From: Clevenger, Ann
Sent: Friday, January 16, 2015 2:11 PM
To: Charonnat Design
Subject: RE: PLN 14268 - 6754 Aitken Dr - [NEW SFD] *Request for Status ((SECOND REQUEST)) <<<third request>>>

From: Clevenger, Ann
Sent: Monday, January 26, 2015 11:53 AM
To: [REDACTED]
Cc: Luster, Gay
Subject: 6754 Aitken Drive (PLN14268) (T1400099)

Ann - Engineering Services has reviewed application **PLN 14268** – a new single family home at 6754 Aitken Court – and has the following comments at this time.

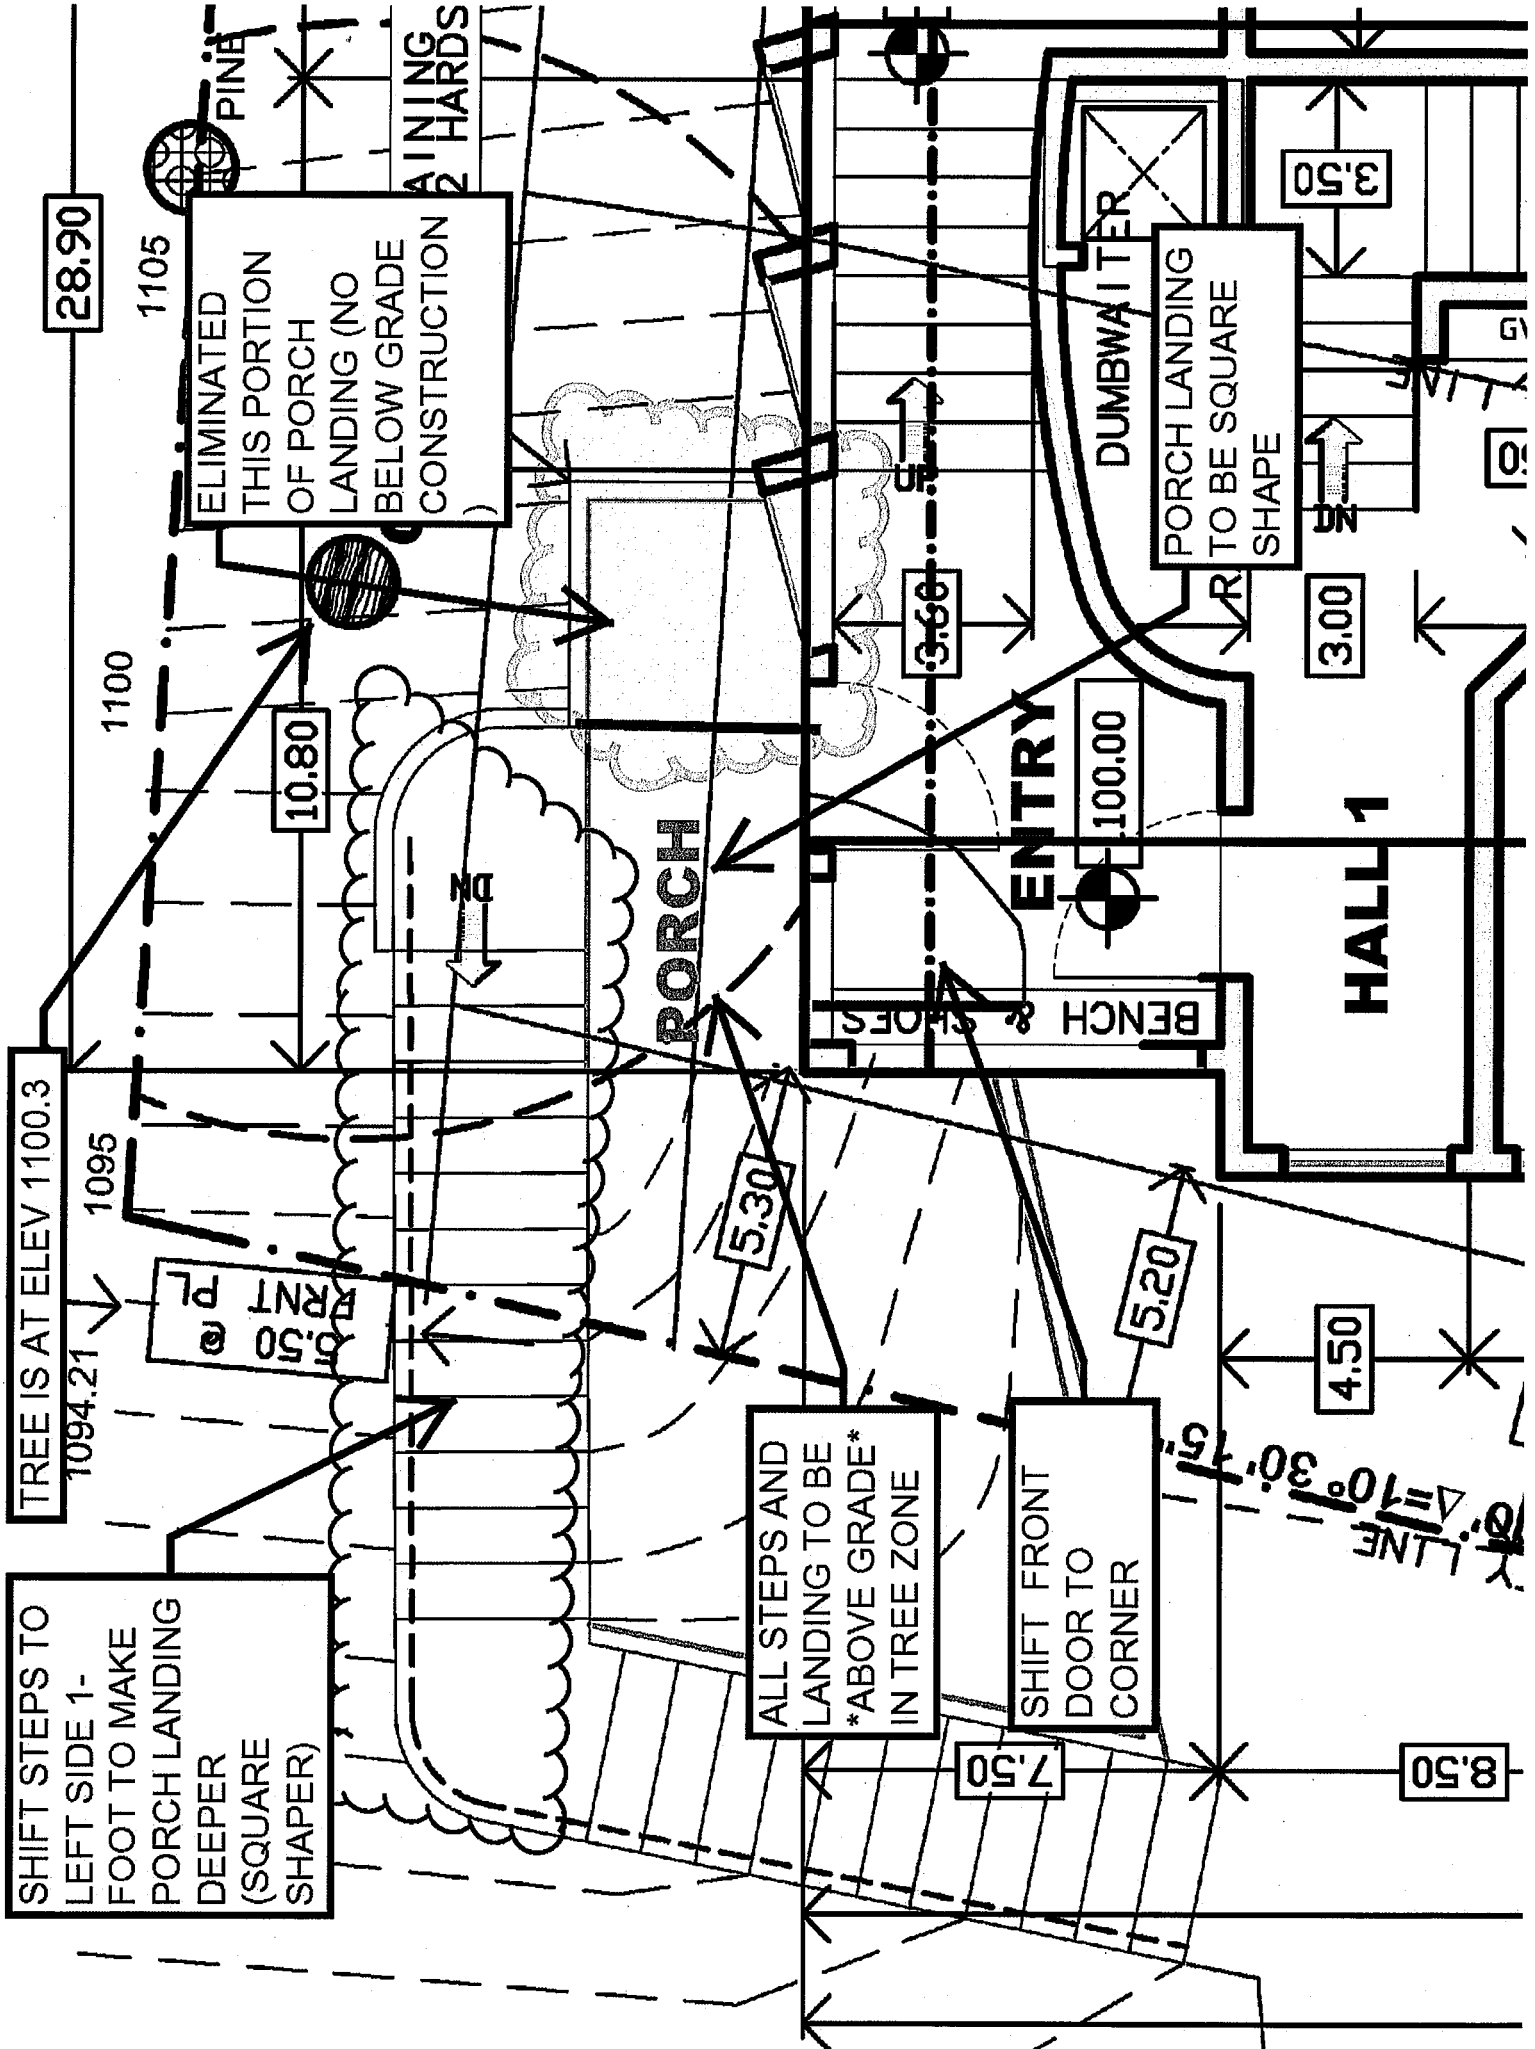
I now see that the stairs going up to Mr. Xiao's front door and his front porch are far within the circle of the canopy and thus the root system of a very large oak tree near the property line with mine. The footprint of the house is even within this circle. That means that the root system will be disturbed and this huge beautiful oak tree could fall due to this problem. It is a steep hillside so it is already leaning, but is held in place by the root system. It looks like this tragedy will be very likely. Mr. Xiao's front porch is only 3 and a half feet from the tree trunk! This is unacceptable.

- eliminate the small portion of front entrance landing to the left (uphill) of front door.
- make the entrance landing more square
- shift the front door to the front (street) slightly to center on landing
- shift second (upper) flight of outside entrance steps to accommodate change in front landing.

SHIFT STEPS TO LEFT SIDE 1-FOOT TO MAKE PORCH LANDING DEEPER (SQUARE SHAPER)

ELIMINATED THIS PORTION OF PORCH LANDING (NO BELOW GRADE CONSTRUCTION)

ATTACHED - DETAILS OF NOTES ON HARDSCAPE AND GRADING PLANS REGARDING HAND-EXCAVATION AND ARBORIST REVIEW OF PATIO OUTLINE IN AREAS NEAR OAK TREES.

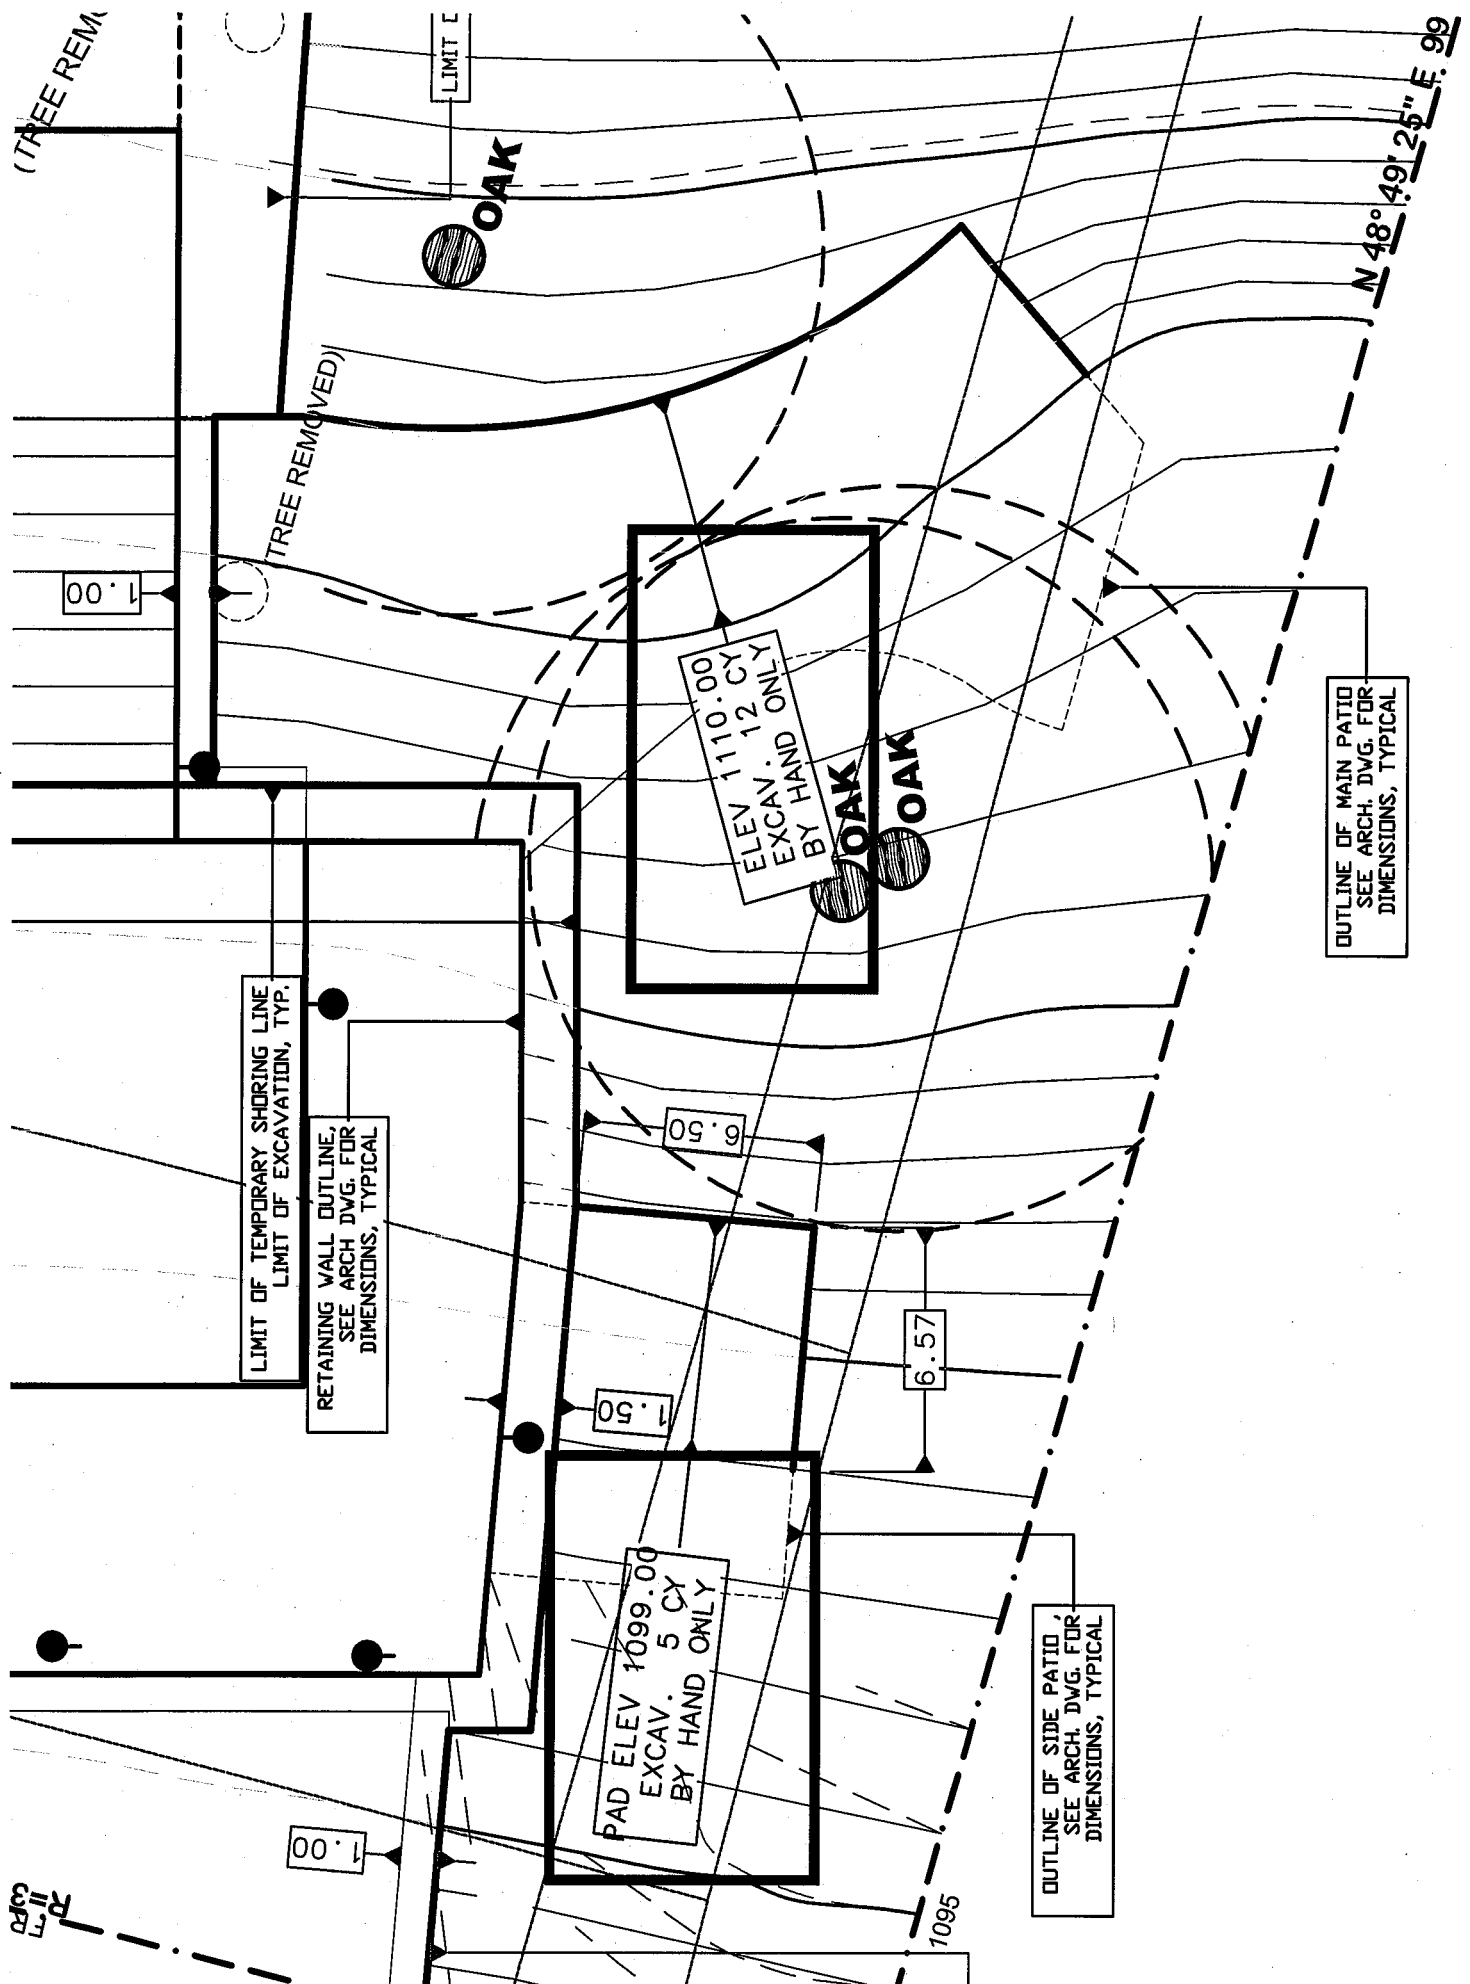
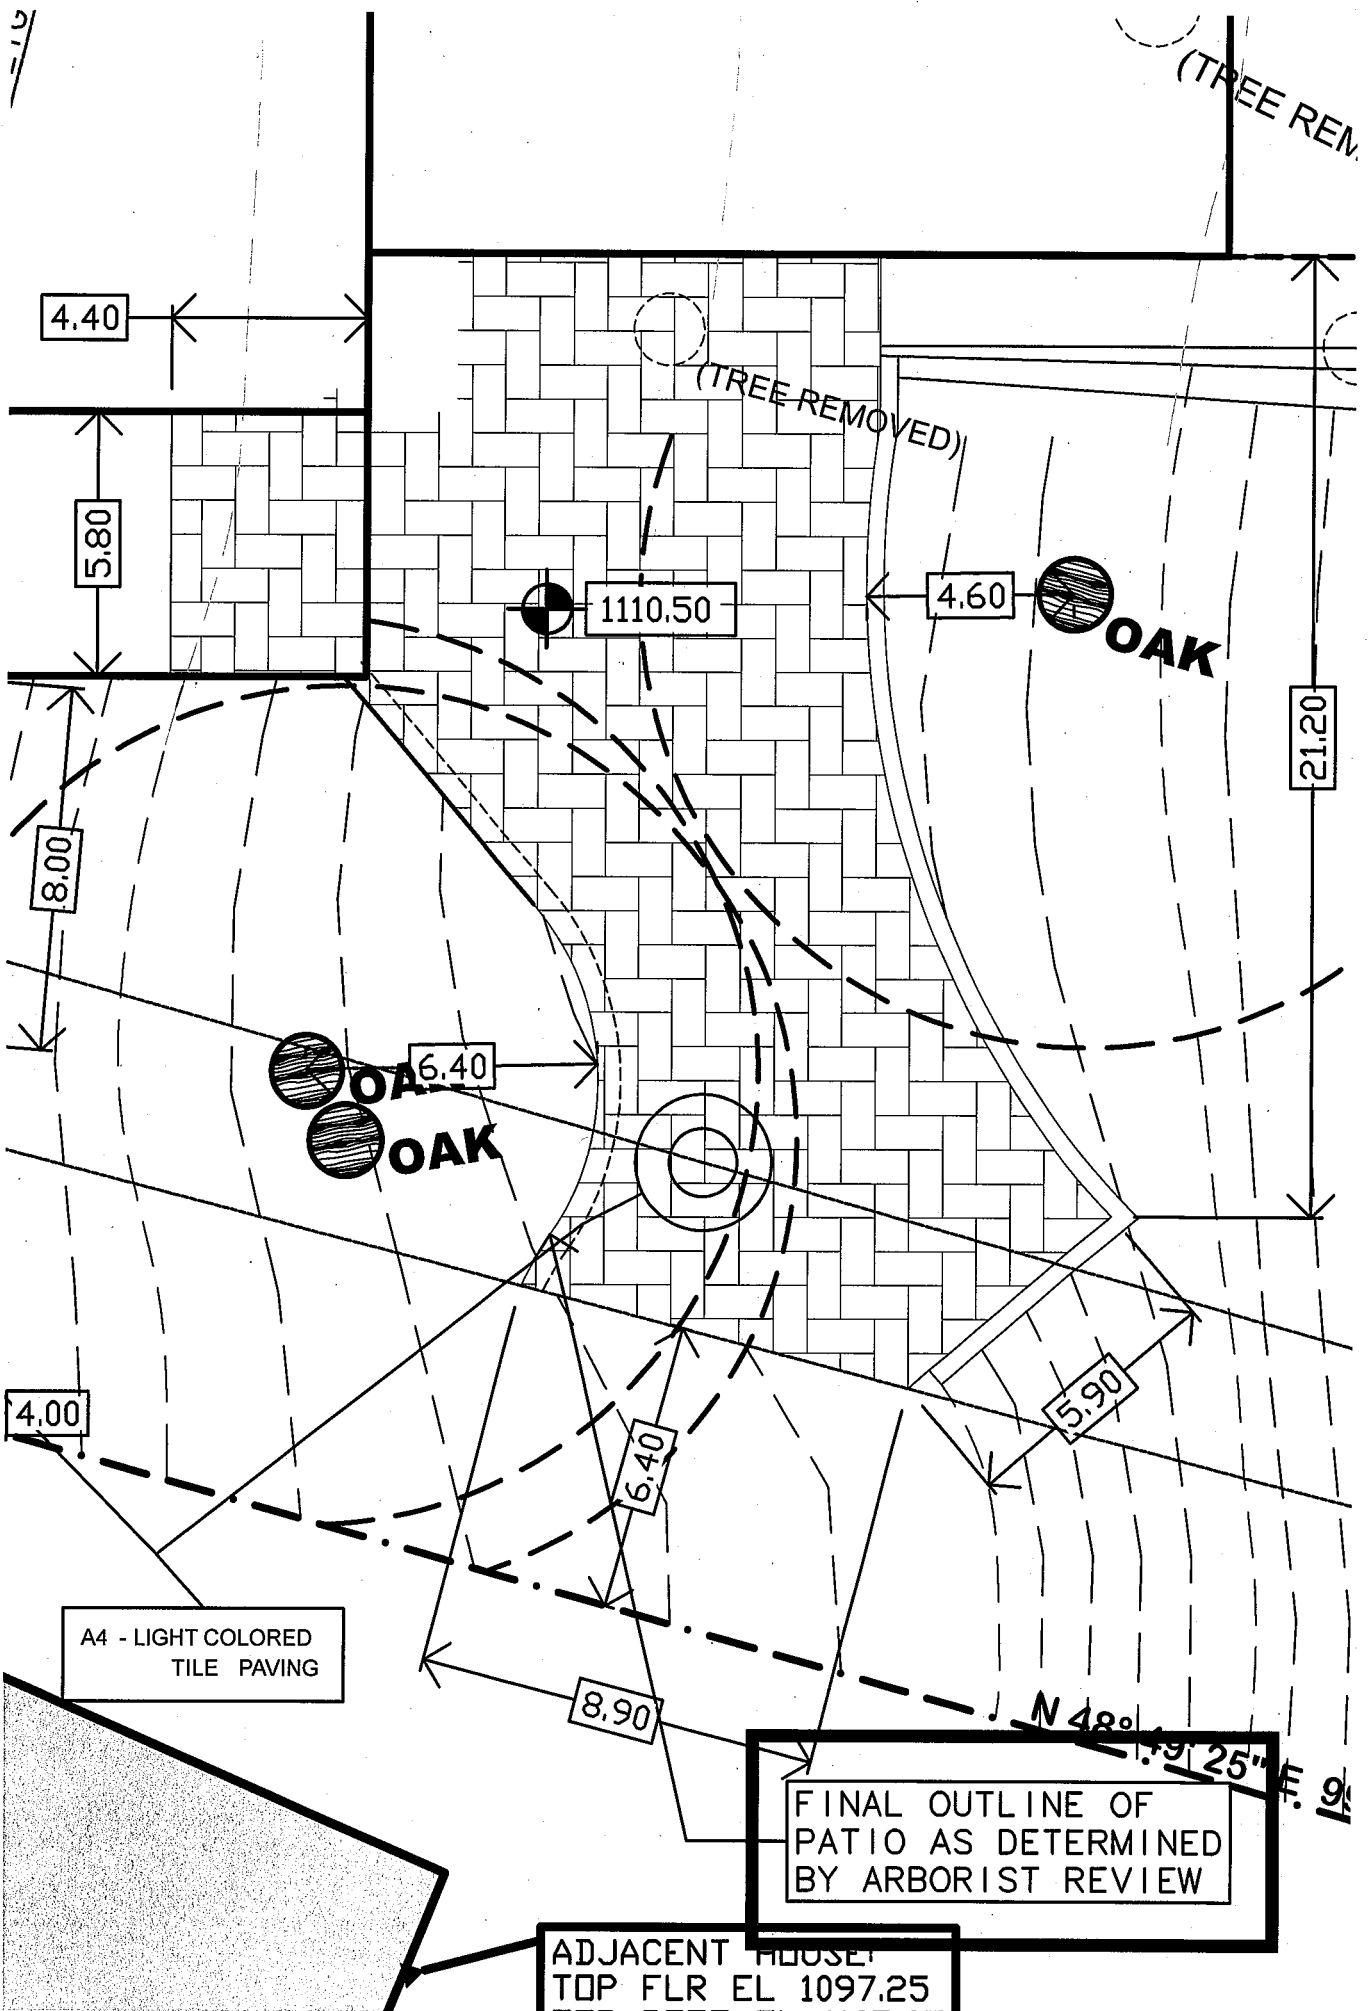
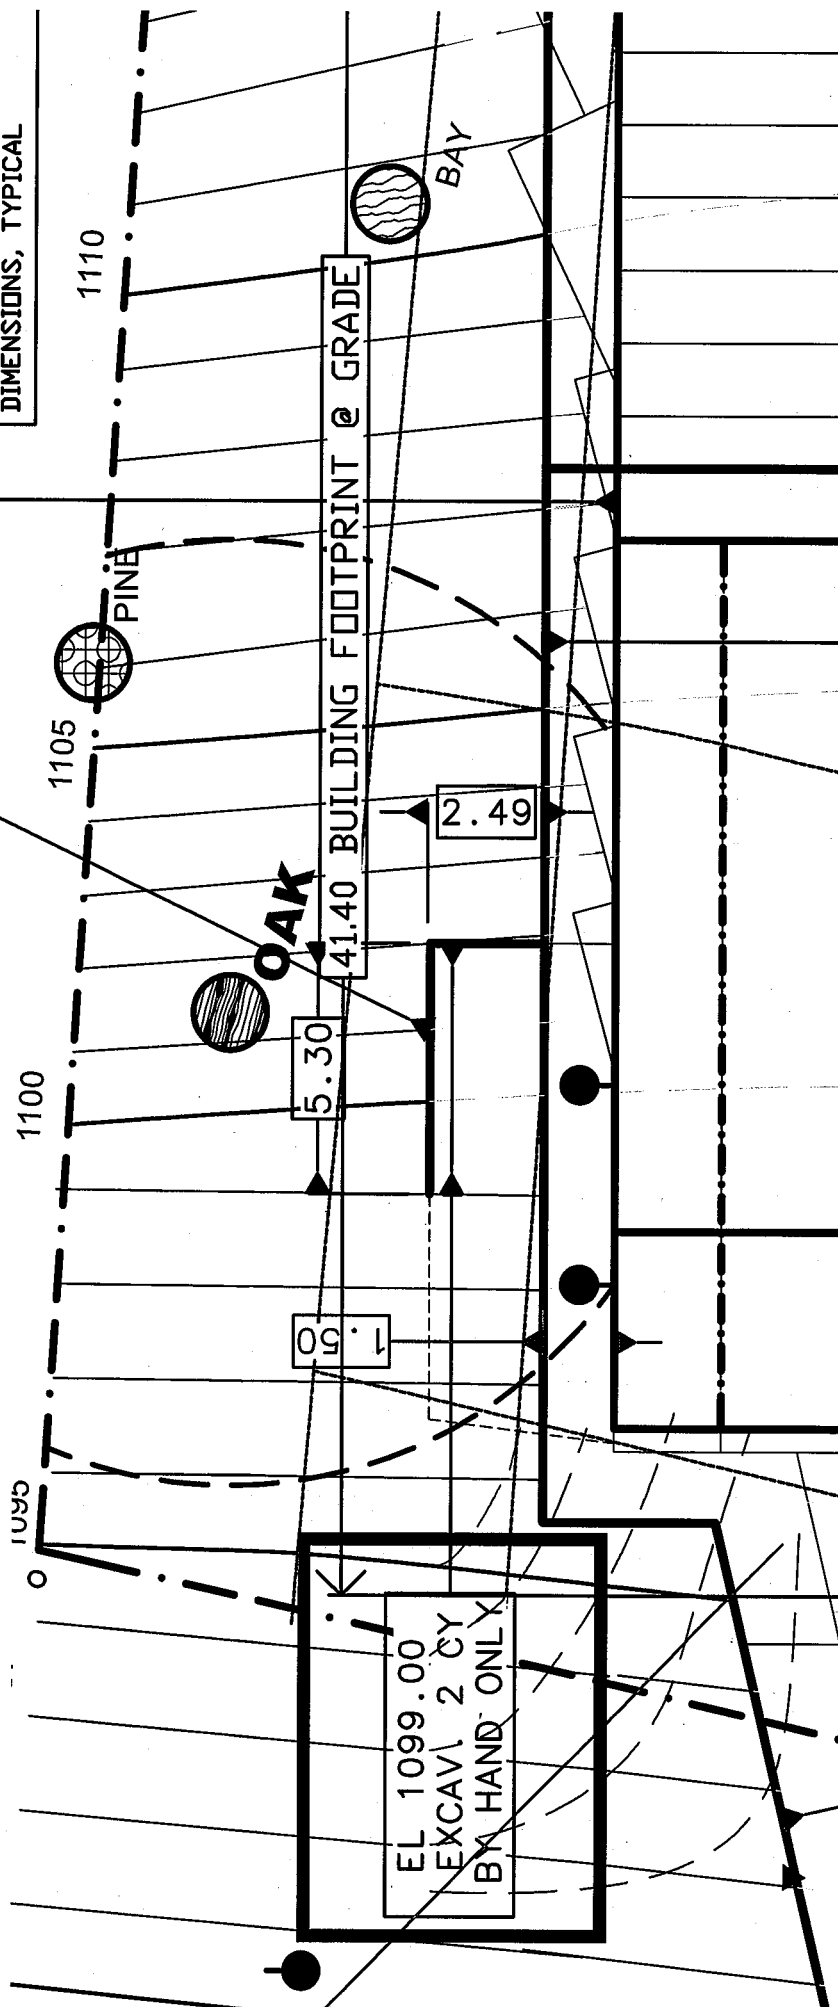
1. The Tree Protection Zone (TPZ's) as described in writing and on a map contained in the Arborist's report dated April 4, 2014, were designed to protect those remaining trees on the site that are not planned for removal. The recommendations require fencing off of these zones and prohibiting activity (parking storing of vehicles, trailers, equipment, chemicals, excavated soil, etc., as well as grading) within these areas. The site plan shows, however,

that there will be stairs, retaining walls, and grading in these areas. Please provide revised plans or more detailed information as to how these TPZ's will be protected.

- **Hand excavation** - the two issues you have broached regarding work near the oak trees are for hand excavation work. This has been clearly noted on the submittal drawings. In case you have missed that, details of the submittal drawings are attached. These detail drawings should be forward to the Tree Division so they are away of the constraints and care that is being taken regarding the oak trees.

- **East (right hand) Patio outline** - In case you missed it, the Hardscape drawing specifically notes that the actual outline of the patio is to be done under the guidance of the arborist. Details with markup of those notes are attached to this email.

OUTLINE OF ENTRANCE PAD
